DEPARTMENT MEMORANDUM

**DATE:** MAY 19, 2022  
**TO:** PLANNING AND COMMUNITY DESIGN COMMISSION  
**FROM:** CARLOS TREJO, AICP  
DIRECTOR OF PLANNING AND COMMUNITY DEVELOPMENT  
**RE:** 9600 ASHMONT DRIVE  
SITE PLAN, COMMUNITY DESIGN, AND CONCEPT STORMWATER  
MANAGEMENT PLAN REVIEW

SUBDIVISION IMPROVEMENT PLAN

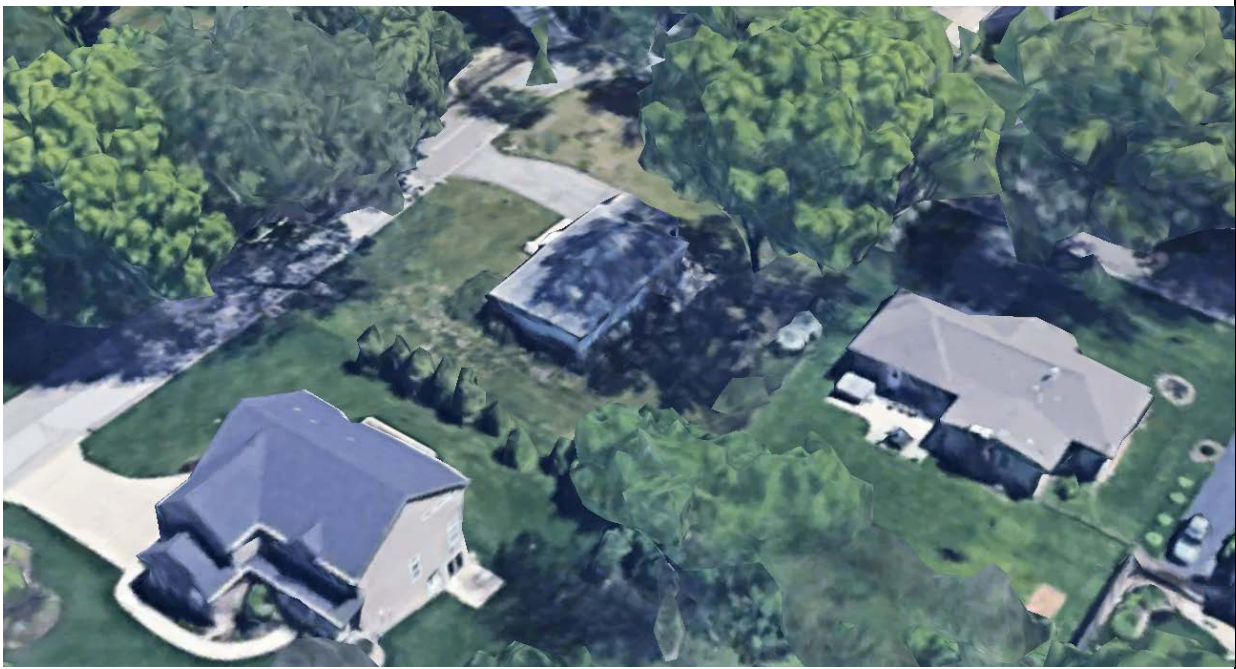
**Stormwater.** There are no adjacent storm-sewer area inlets downstream to utilize near the property grounds. There is one on the north along the street, but its elevation is higher. While onsite detention is provided along the southwest corner of the property, it would benefit to shift the detention and detention daylight further north towards the north front yard.

- As noted above, the detention pit and daylight should be shift further north to allow for the excess stormwater release to permeate and slow in velocity.
- Sump pump discharge. The location of the sump pump is illustrated in the building plans at the northwest corner of the house (by the street side). The discharge point is illustrated in the Site Plan Improvements. Staff has no concerns regarding location and placement.

1. The detention pit and daylight be shifted further north to allow for the excess stormwater release to permeate and slow in velocity.
